# SCHWEIZER SERVICE NOTICE

NOTICE NO. N-208

SUBJECT: IDENTIFICATION AND POSSIBLE REPLACEMENT OF TAIL ROTOR FORK BOLT.

**FIGURE 1.**

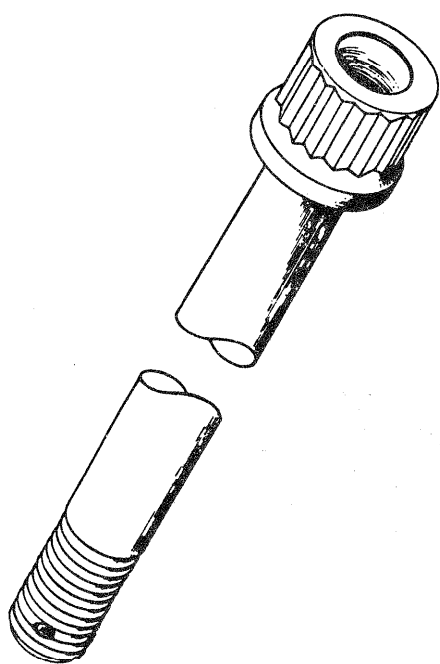
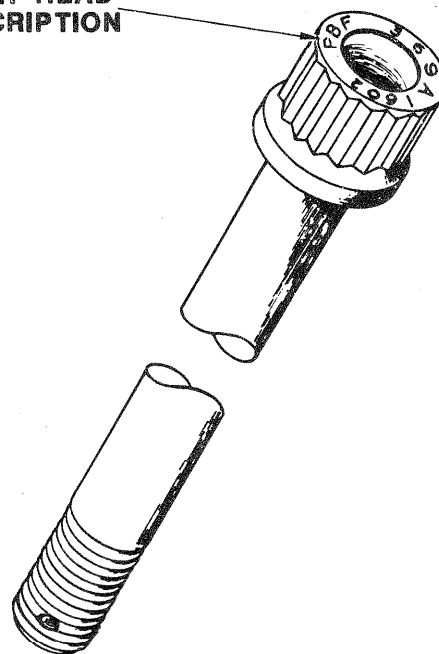
- a. Visually examine the inscription on the tail rotor fork bolt (Figure 1).

The head of properly processed bolts are inscribed as shown in Figure 1, Detail B. If the helicopter is equipped with an inscribed bolt (Figure 1, Detail B), further inspection and disassembly is not required. Record compliance with this Service Information Notice in Compliance Section of Helicopter Log Book, if the fork bolt is inscribed (Figure 1, Detail B).

Some 369A1602 tail rotor fork bolts manufactured in 1986 received incomplete processing. These bolts lack the inscription on the head (Figure 1, Detail B). However, since some properly processed fork bolts (369A1602) were manufactured without the inscription (prior to 1975), we cannot conclude that all uninscribed bolts were improperly processed. All uninscribed bolts manufactured in the year 1986 must be removed from service and stock. Uninscribed bolts whose manufacture date cannot be positively determined to be prior to 1986, must also be removed from service and stock.

- c. Check stock and remove all improperly processed bolts. (Contact your Schweizer Service Center or Distributor for disposition of bolts.)
- d. Remove improperly processed bolts from tail rotor assembly as follows:

**FIGURE 2.**

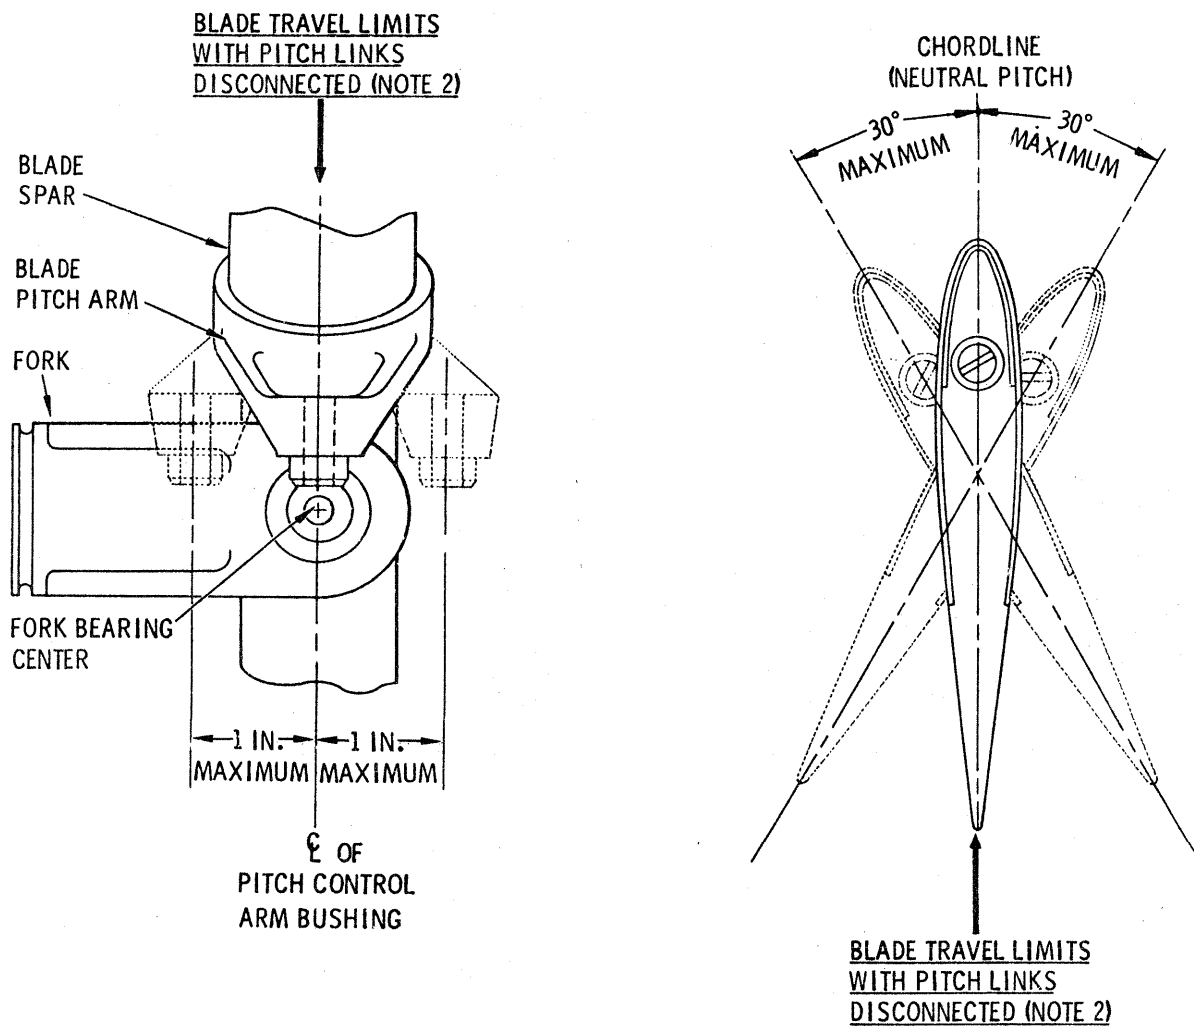
When the blade and hub assembly is removed from the helicopter, and at all times when the pitch control links are disconnected, do not allow blade pitch angle to exceed 30 degrees from the neutral position. (See Figure 2.) Unrestricted rotation of blades on the hub can excessively bend or stretch the internal tension-torsion strap assembly and cause undetected damage to the strap assembly, and an out-of-balance condition for the tail rotor.

**NOTE 2. CAUTION:** DO NOT ALLOW BLADE PITCH TRAVEL TO EXCEED LIMITS SHOWN. ROTATING THE BLADES TO EXCESSIVE PITCH ANGLES MAY RESULT IN UNDETECTED DAMAGE TO TENSION-TORSION STRAP ASSY.
